NORTHEAST UTILITIES

Docket No. 50-423
B11238

Millstone Nuclear Power Station, Unit No. 3
Millstone 3 Site Visit by Auxiliary Systems Branch Reviewer, June 13, 1984

ASB-22 PRESSURE AND TEMPERATURE PROFILES FOR PIPE BREAKS OUTSIDE CONTAINMENT

Figure 1
Main Steam Valve Building
Nodal Diagram

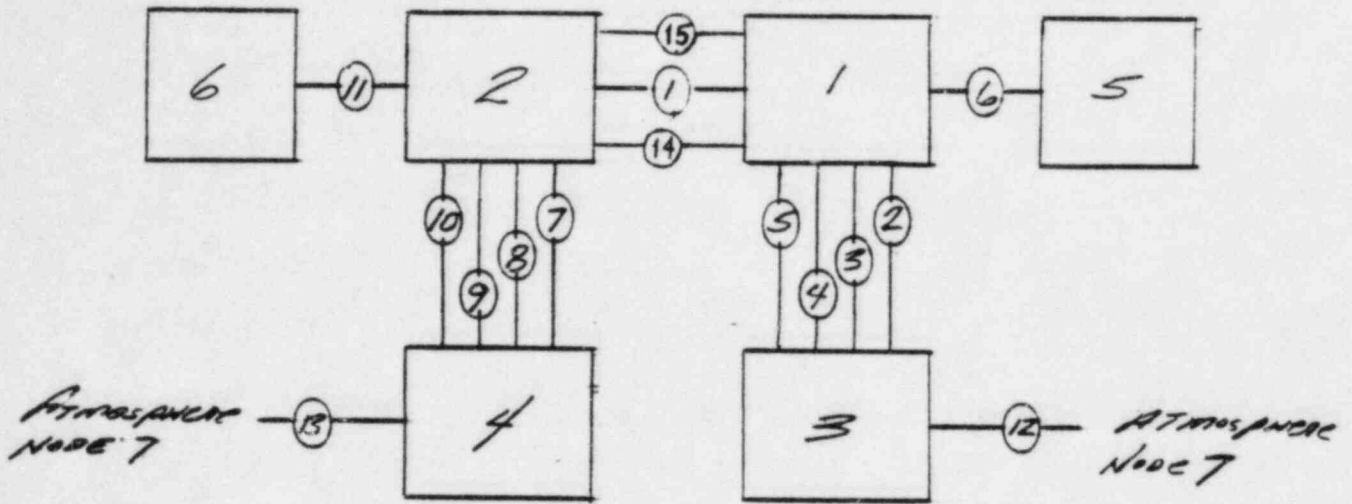
Provide the following information to perform an independent calculation for verifying environmental conditions in a compartment (e.g. Main Steam Valve Building) after a high energy line break.

- v. number of vents and vent areas (square feet) for each vent; and
 - vi. compartment wall height (feet) and
 - c. Simple compartment and interconnection diagram.

The MSVB is modelled by six interconnected nodes as shown in Figure 1. A sketch showing the location of the nodes is given in Figure 2. Input data for the thermal-hydraulic calculations are described below.

FIGURE 3
 MILLSTONE 3 MSVH 1.0SQFT.MSLB IN NODE 1
 PRESSURE VS. TIME
 PROFILE NODES 1 THRU 6

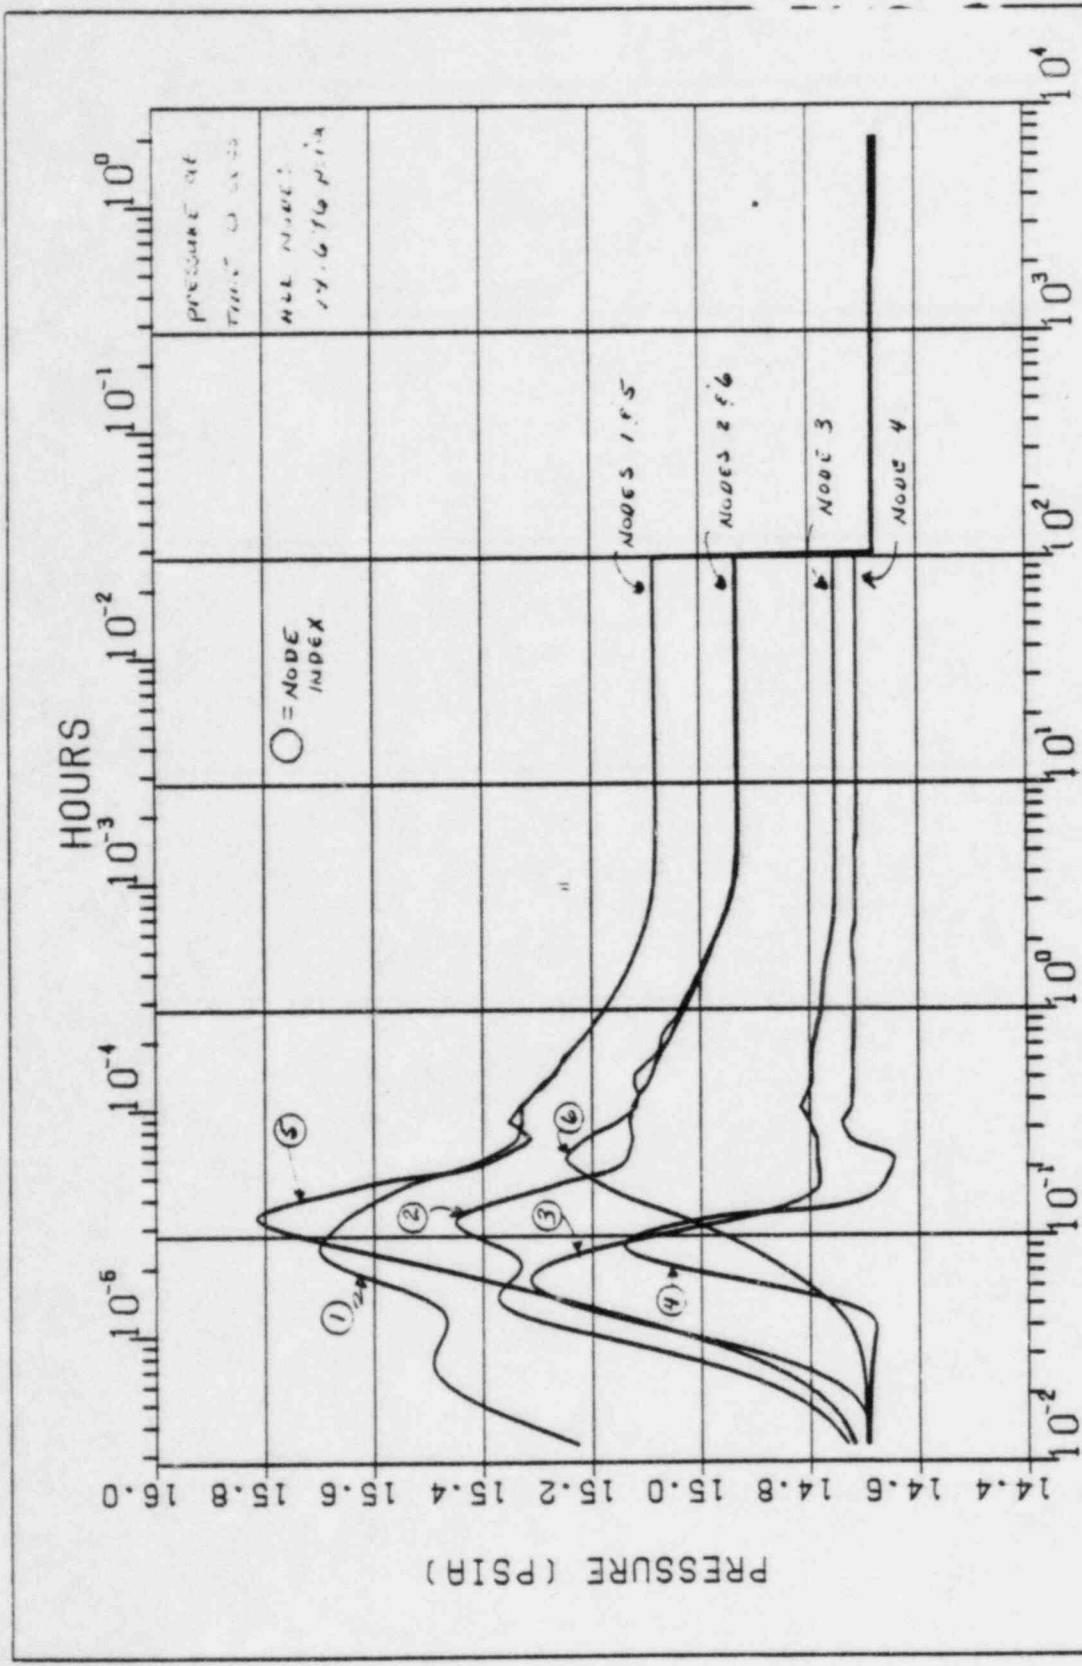
4. Utilities analysis results:
 - a. Temperature versus time curve (peak temperature specified);
 - b. Pressure versus time curve (peak pressure specified); and

The peak calculated pressure and temperature in the MSVB was 15.82 psia and 292.4°F, respectively. Complete pressure and temperature transients for each node of the building are given in Figures 3, 4 and 5. The relative humidity is 100% for the duration of the transient.
